SSDA Mods

1.1 Facade Materiality

Modification 1 to SSDA

Cox Architects

Proposed Northern Façade [SMCSWSPS-FOS-OSN-AT-DWG-960004 Rev E]

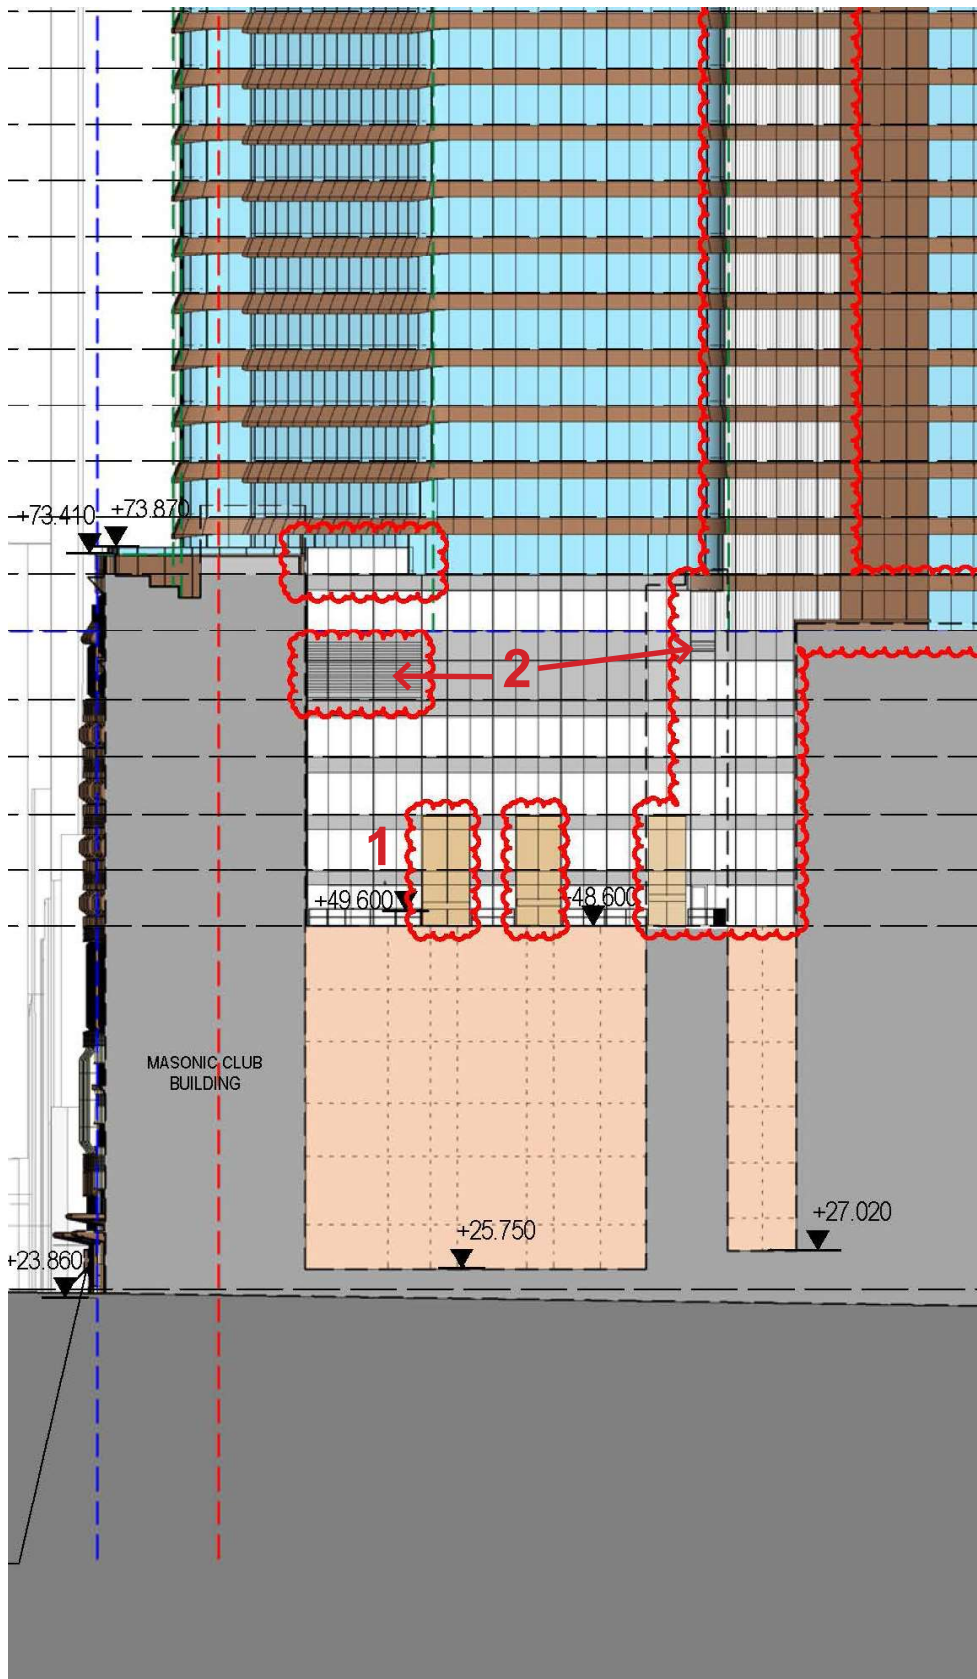
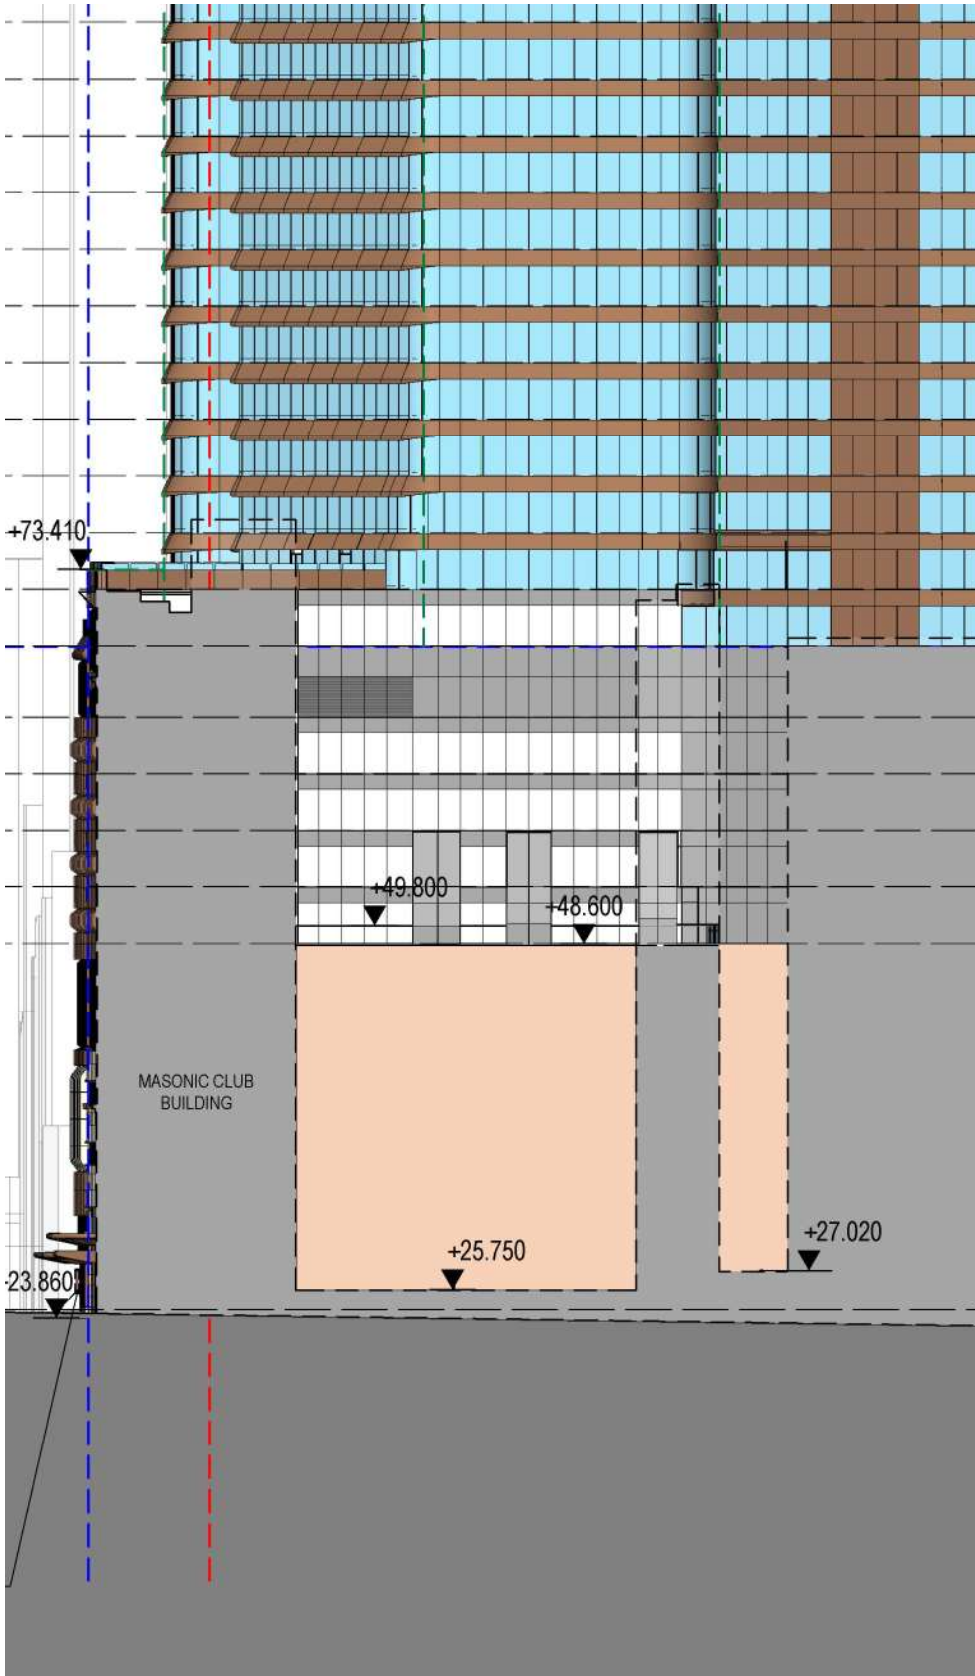
The northern façade of the podium abuts the Masonic Club Building and the National Building (Ashington Place) which both have lightwells adjacent to the shared boundary as illustrated. Maintaining light to these lightwells was a key driver in the chosen materiality for this façade

- 1. White spandrel glazing noted on the Northern Light well columns is clarified to be Metal Cladding as it has been incorrectly coloured on the SSDA documents.
- 2. Louvre extent updated to match mechanical intake / exhaust layout.
- 3. Fluted Glazing added to key plan

Proposed Northern Façade [SMCSWSPS-FOS-OSN-AT-DWG-960004 Rev E]

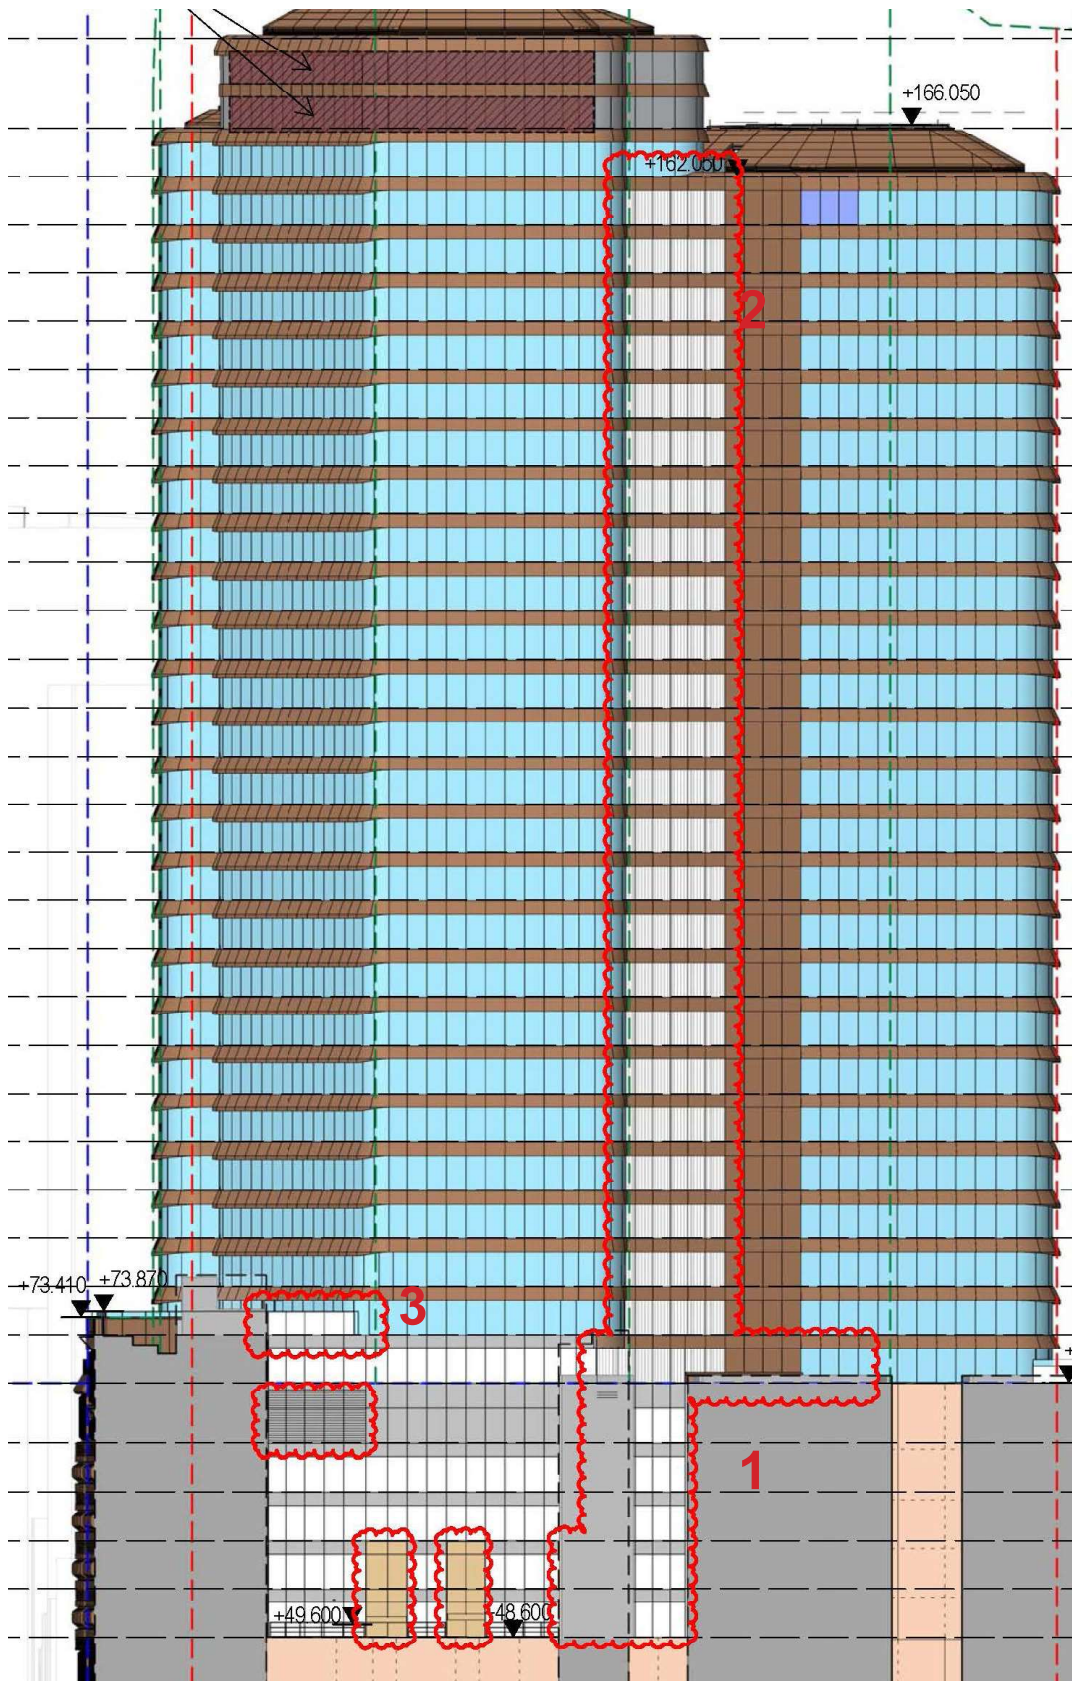
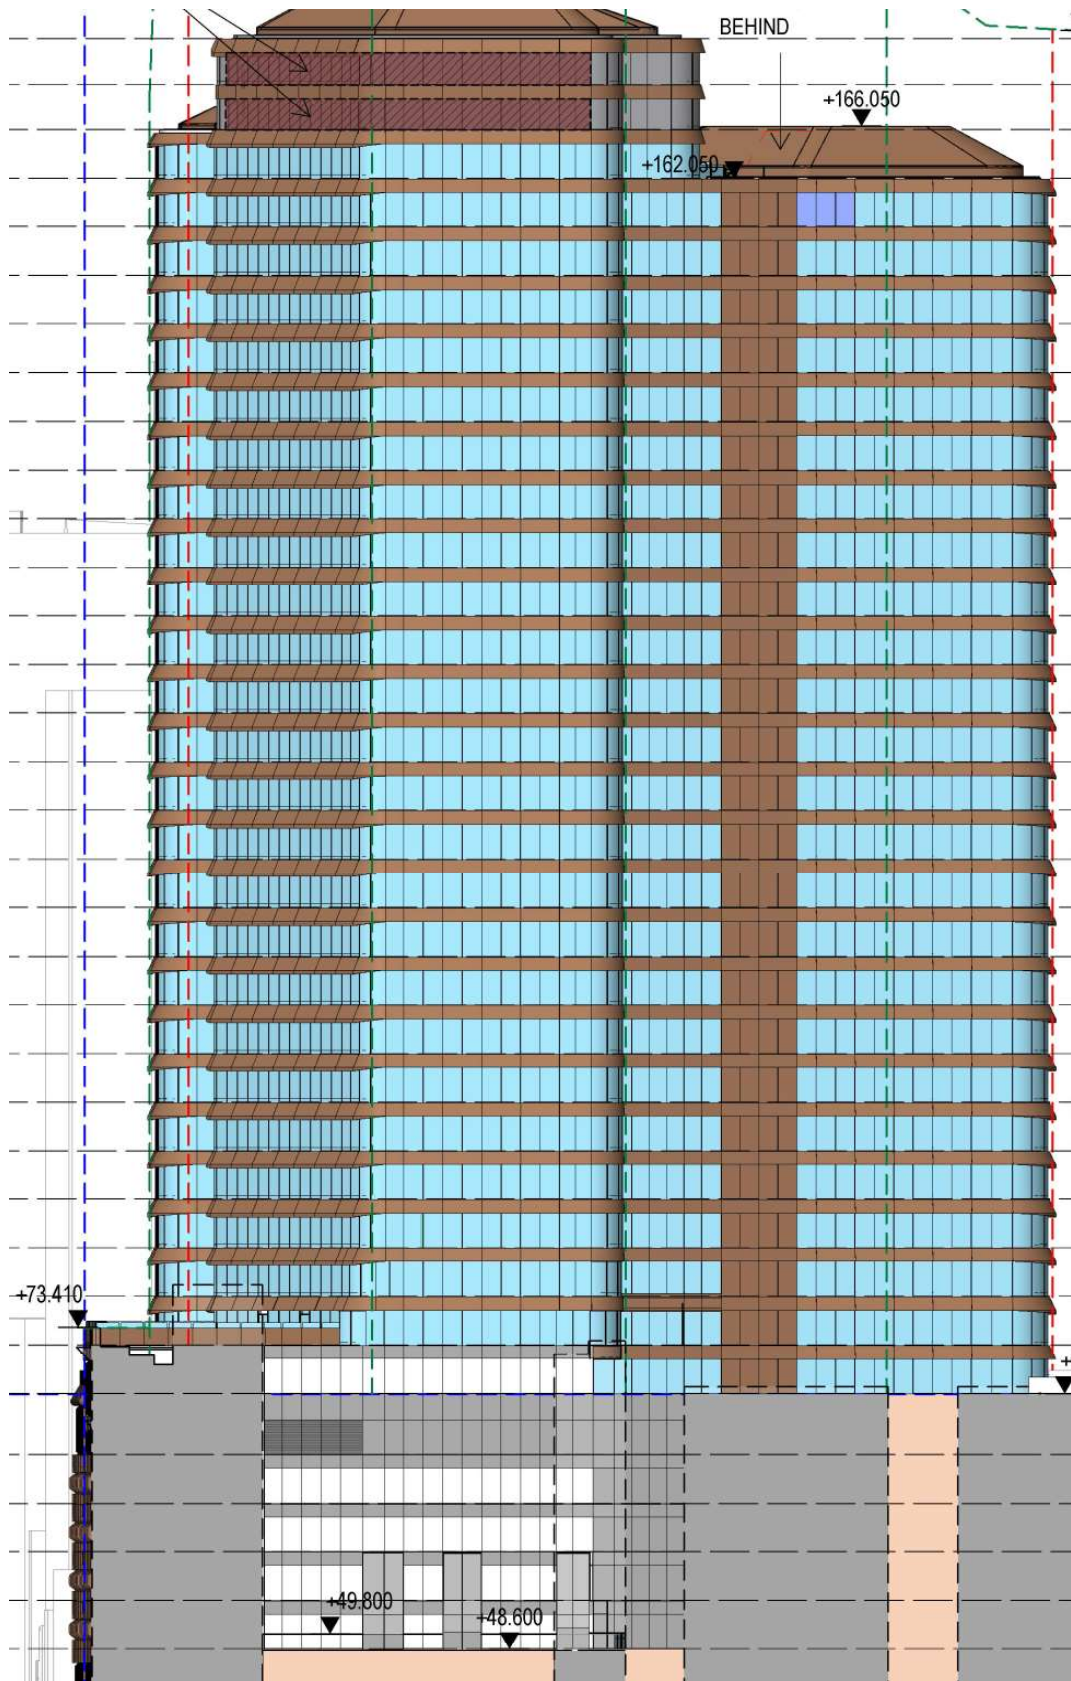
- 1. White spandrel glazing on the northern facade is modified to be translucent curtain wall on North facing adjoining neighbours.
- 2. The approved plans show a glass curtain wall adjacent to the amenities and this has been corrected to a fluted glass. This will have the same neutral colour and appearance as originally intended.
- 3. Balustrade has been updated to reflect a continuation of the translucent glazing below.

Impacts/ Non-Impacts to adjoining Light Well

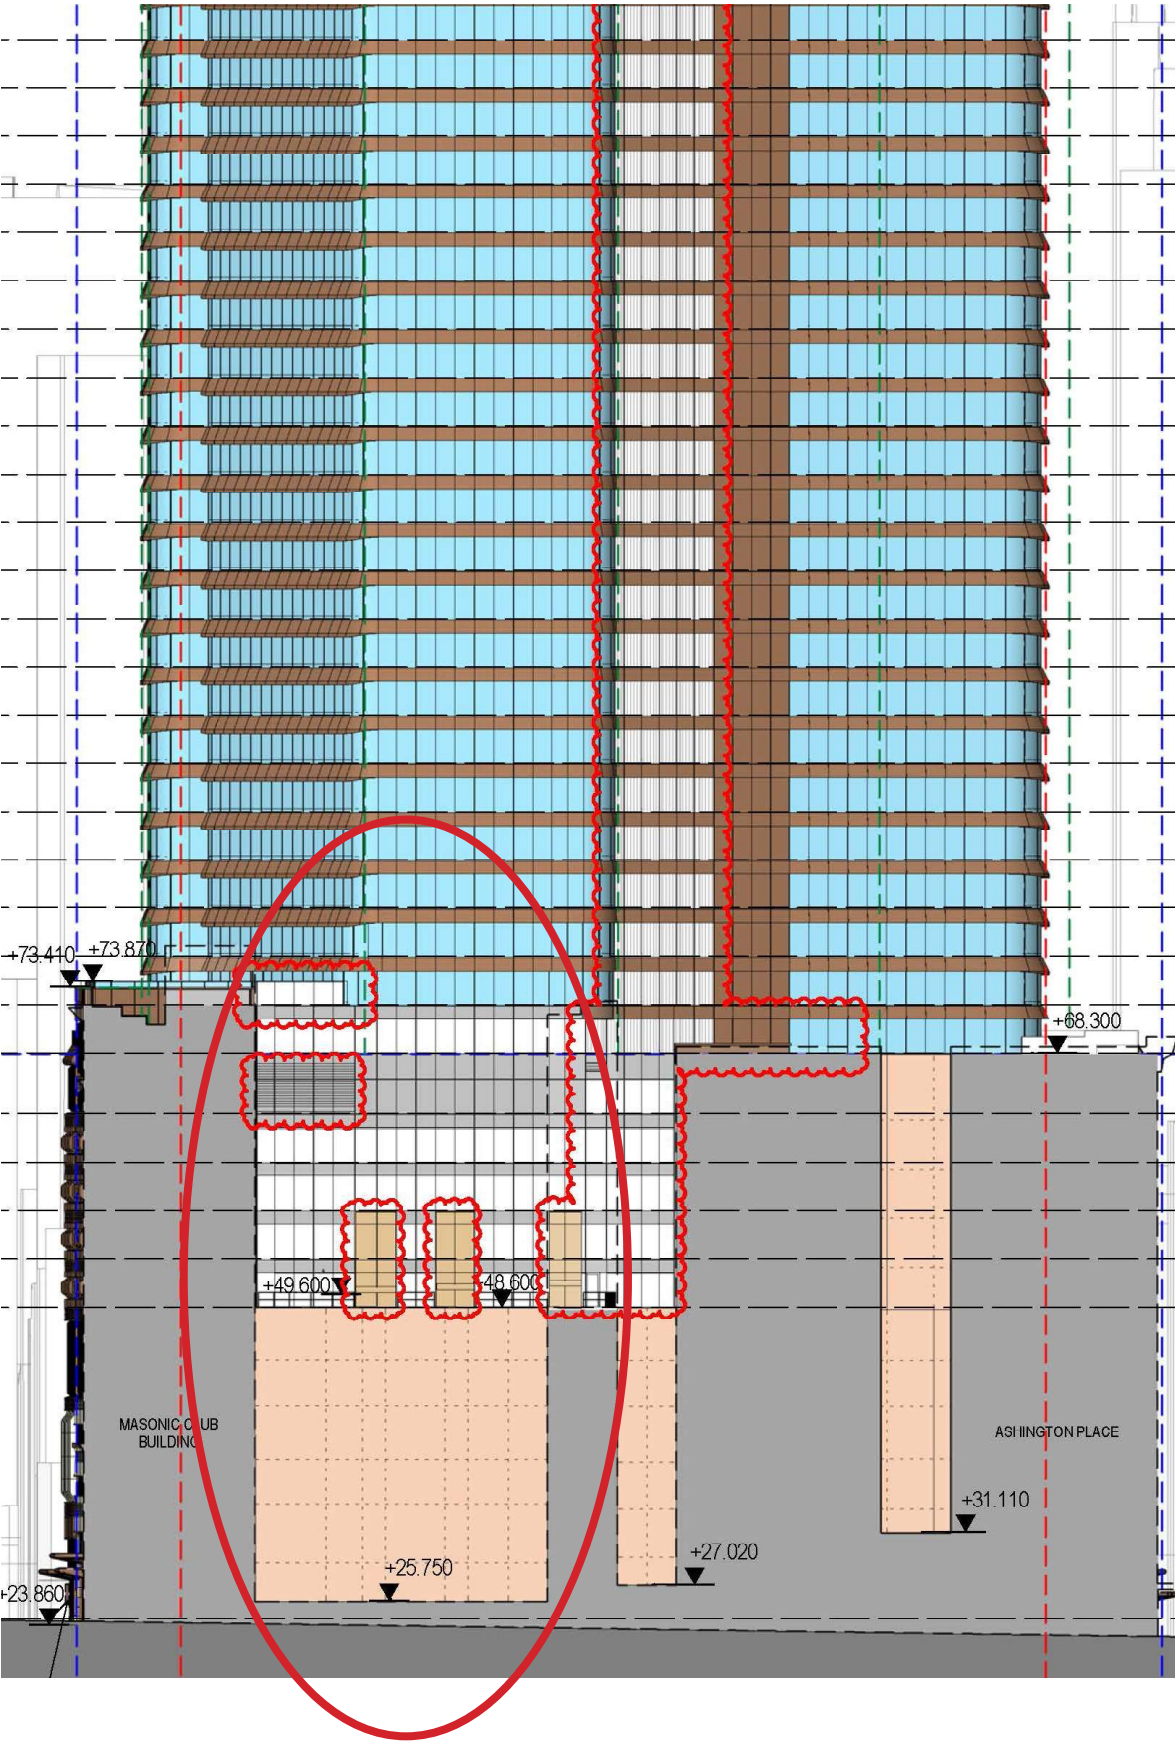
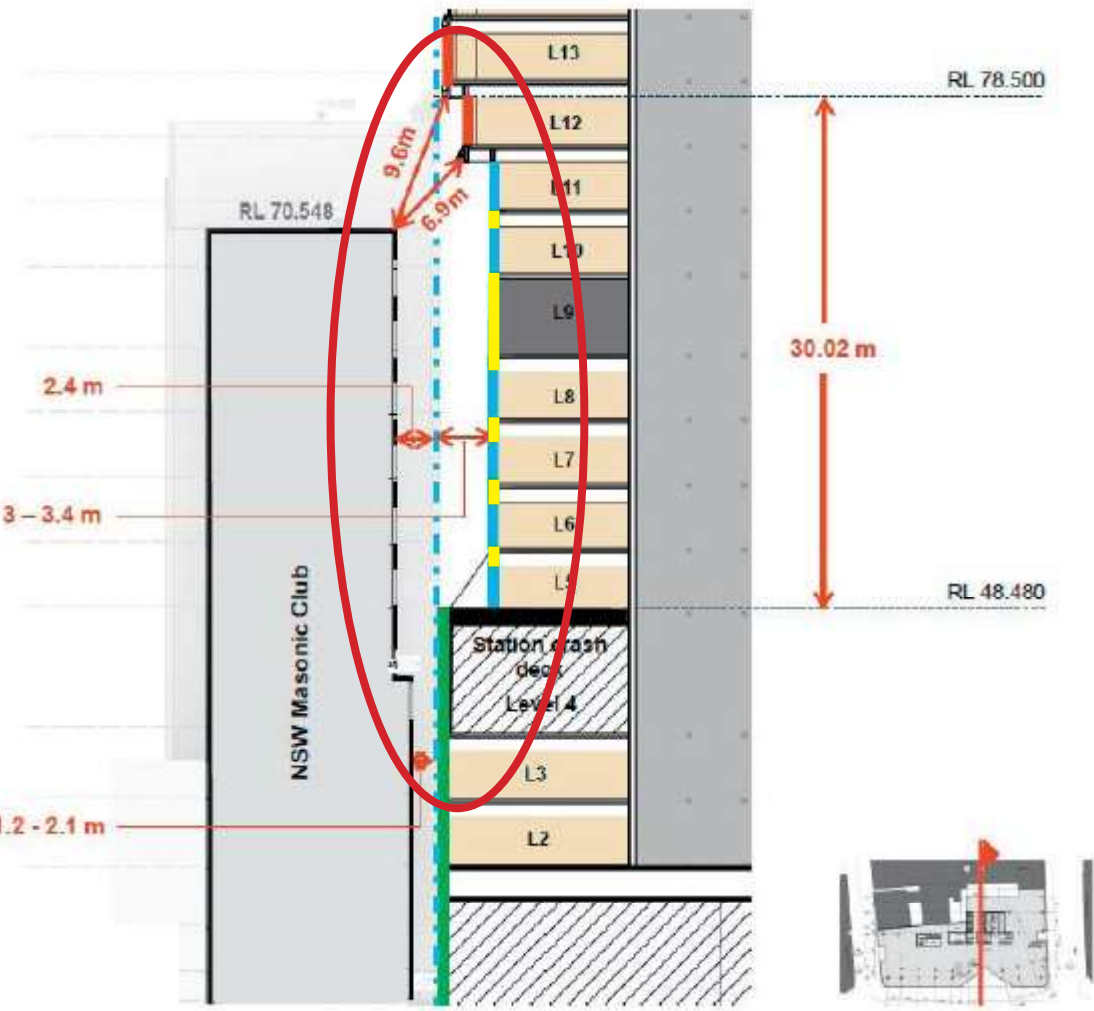
The modifications proposed to the adjoining light well is consistent with the intent of the original SSDA Proposal, as the form will be the same there will be no impacts on the original SSDA amenity proposed. The adoption of translucent glass where the office amenities and adjoining office facades are located is an enhancement to the privacy of the development occupants and the neighbouring occupants.

Proposed East Elevation [SMCSWSPS-FOS-OSN-AT-DWG-960003 Rev E]

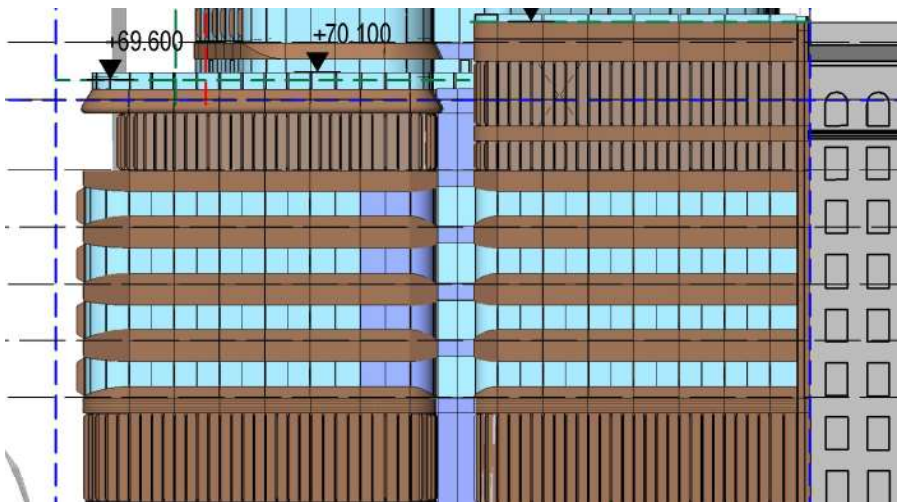
A correction has been made to the podium facade (level 5 through to level 9) on the eastern and western elevations to accurately show the corrugation detailing. This change is a graphical fix as illustrated.

- 1. Correction to Eastern Podium Façades.
- 2. Correction to Western Podium Façade.
